## **Instruction Sheet**

Subject: 8263468, 8263469, 8263470 SIB (Smart Interface Board) Replacement Instructions Models affected: Japan LOV, FilterQuick Touch Fryers

**Figure A**

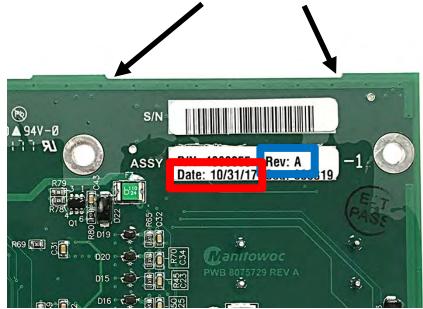
Modified Rev A boards with date code 10/31/17 (see red box) or later have slots that have been notched at the top (see Figure A) and can be used.

## Slots notched at the top indicate modified boards.

Ensure the replacement SIB boards are marked with modified Rev A or higher revision (see blue box).
